Attachment J3

Submissions

Planning Submission
For: SP 67057: 23 Billyard Avenue, Elizabeth Bay

Development Application ('DA') No. 2023/0727
'Demolition of existing buildings, tree removal, excavation and construction of two new residential flat buildings, 6 to 8 storeys in height, with 22 apartments, 4 basement levels containing 27 car spaces, rooftop terraces, swimming pools and associated landscaping works including new tree plantings. The application is Integrated Development requiring the approval of Water NSW under the Water Management Act, 2000.'

10.45am Proposed

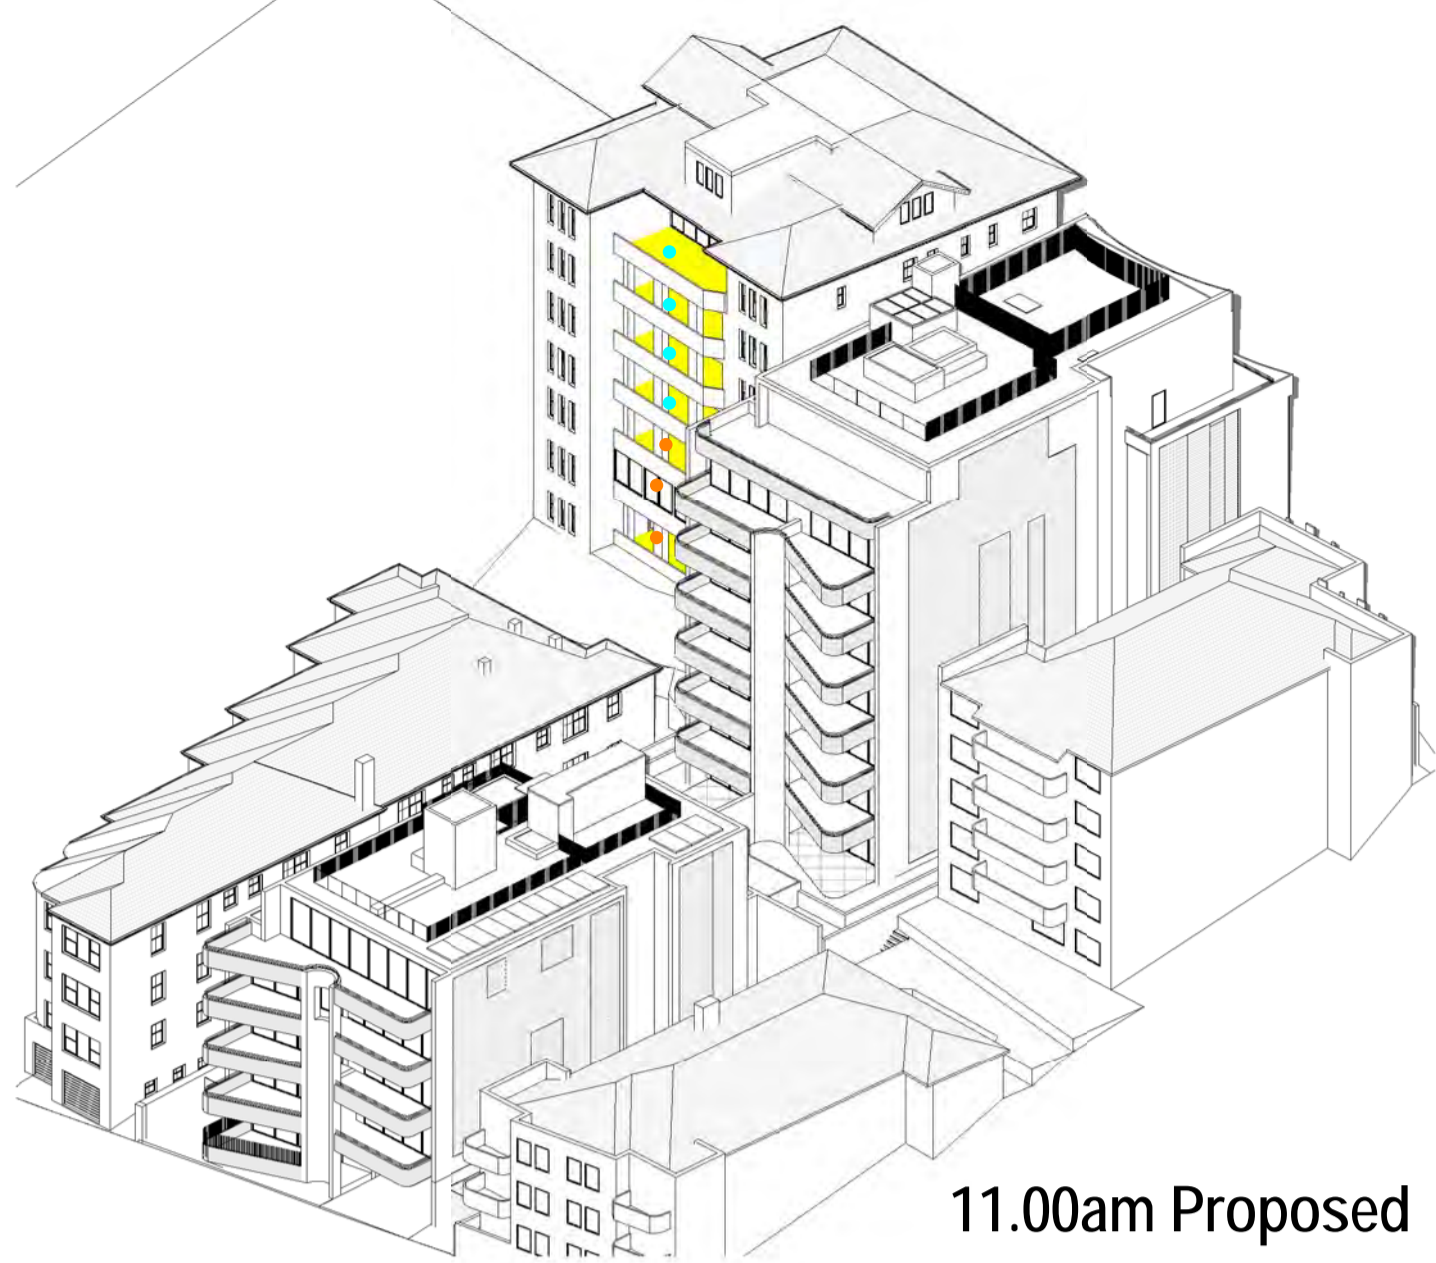
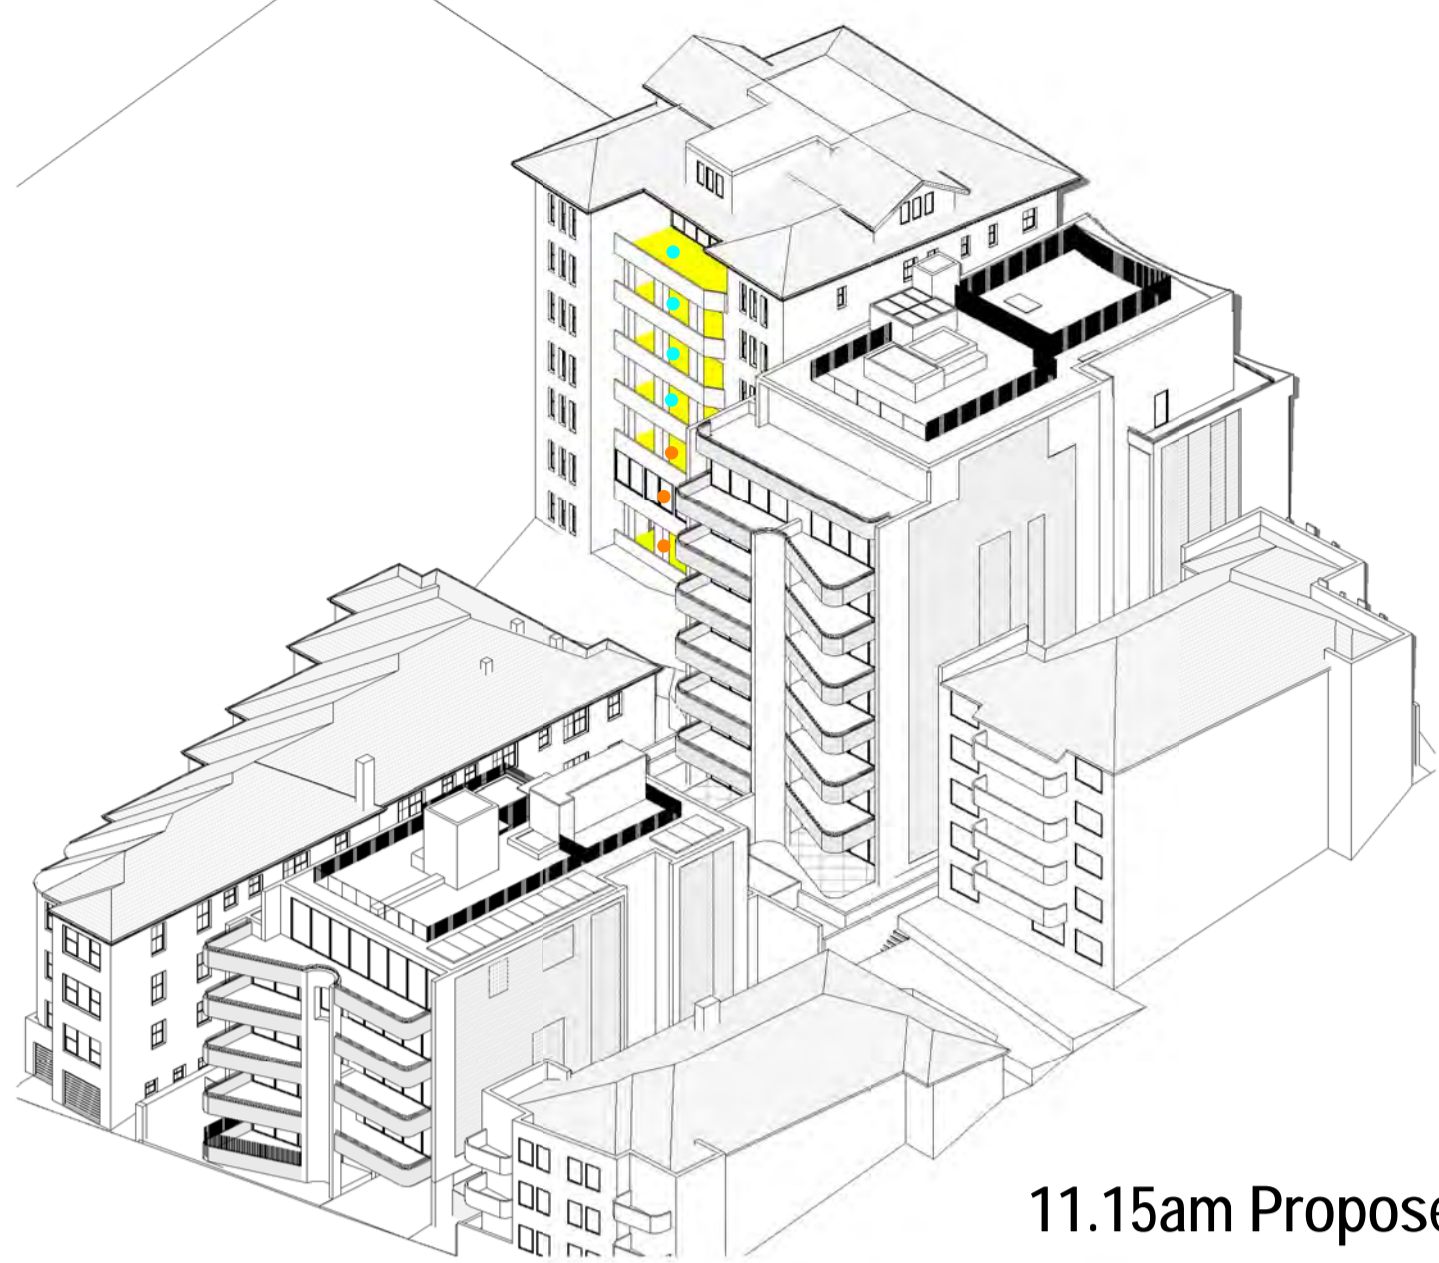
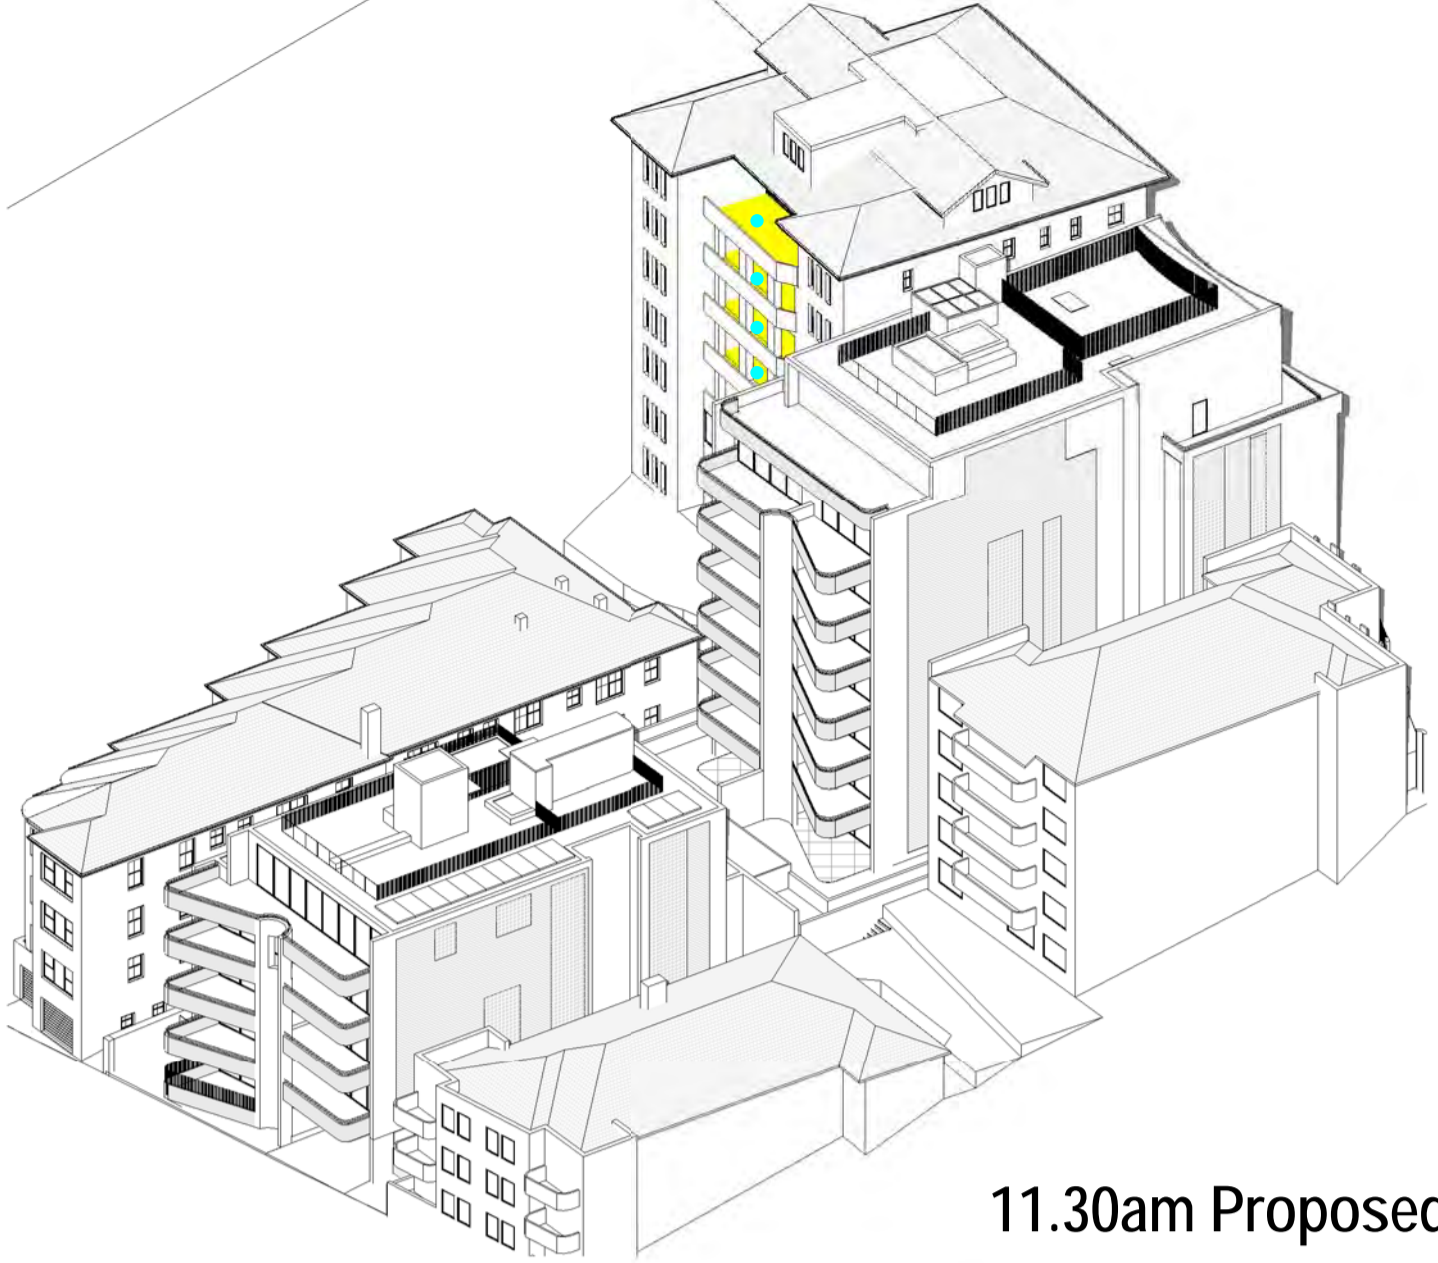
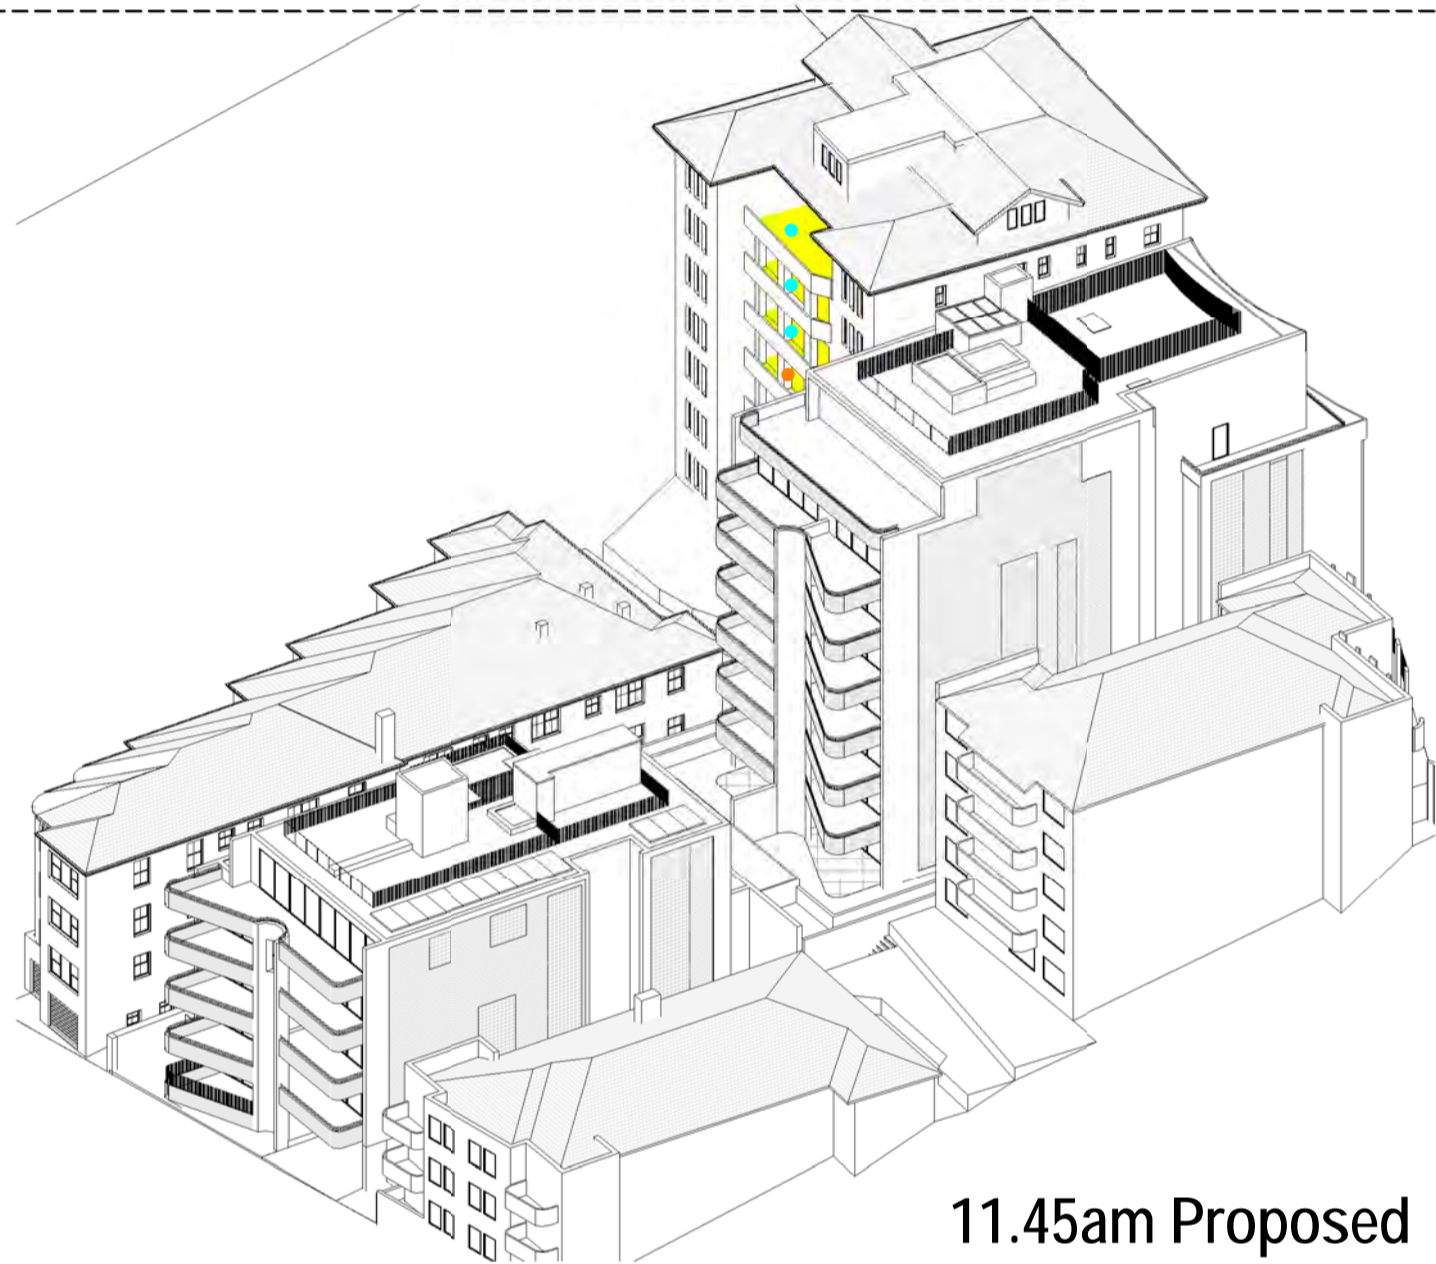
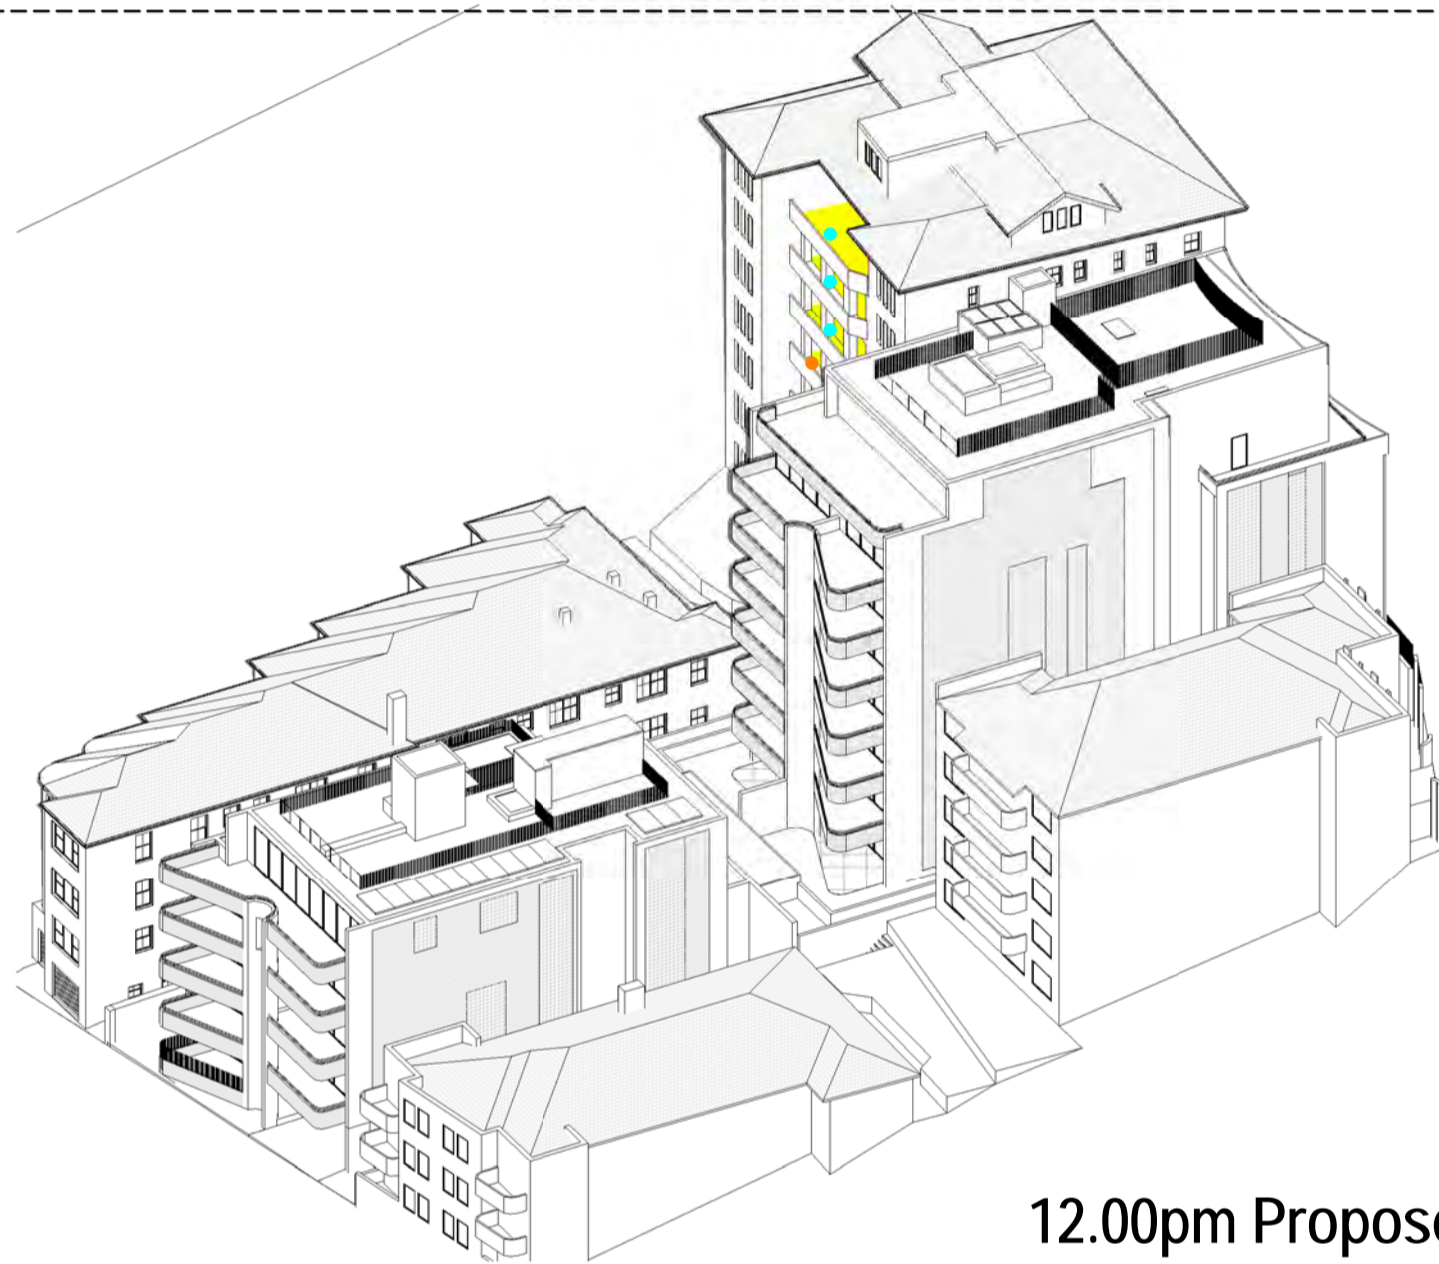
The solar diagrams show worsening of solar access to these only areas of living space (no balconies available). It is noted that staff requested 15 minute intervals and these have not been provided for 23 Billyard Avenue.

1.30	1.45	2.00	2.15	2.30	2.45	3.00	
UNIT 6 LIV	X	X	X	X	X	X	X	
UNIT 7 LIV	X	X	X	X	X	X	X	
UNIT 1 LIV	•	•	•	•	•	•	•	
UNIT 17 LIV	X	X	X	X	X	X	X	
UNIT 18 LIV	•	•	•	•	•	X	X	
UNIT 11 LIV	•	•	•	•	•	•	•	
UNIT 26 LIV	•	•	•	X	X	X	X	
UNIT 27 LIV	•	•	•	•	•	•	•	
UNIT 21 LIV	•	•	•	•	•	•	•	
TOTAL HOURS WINDOWS SOLAR ACCESS JUNE 21ST:								
9.00AM - 3.00PM								
	EXISTING:	PROPOSED:	ACCESS LOST:	% LOST:				
UNIT 6 LIV	0 HOURS	0 HOURS	0	0%				
UNIT 7 LIV	0.25 HOURS	0 HOURS	-0.25 HOURS	100%				
UNIT 1 LIV	6.0 HOURS	2.0 HOURS	-4.0 HOURS	66%				
UNIT 17 LIV	3.25 HOURS	2.25 HOURS	-1.0 HOUR	30%				
UNIT 18 LIV	1.5 HOURS	1.25 HOURS	-0.25 HOURS	16%				
UNIT 11 LIV	6.0 HOURS	2.0 HOURS	-4.0 HOURS	66%				
UNIT 26 LIV	4.25 HOURS	5 HOURS	+0.75 HOURS	+17%				
UNIT 27 LIV	6.0 HOURS	6.0 HOURS	0	0%				
UNIT 21 LIV	6.0 HOURS	3.5 HOURS	-2.5 HOURS	42%
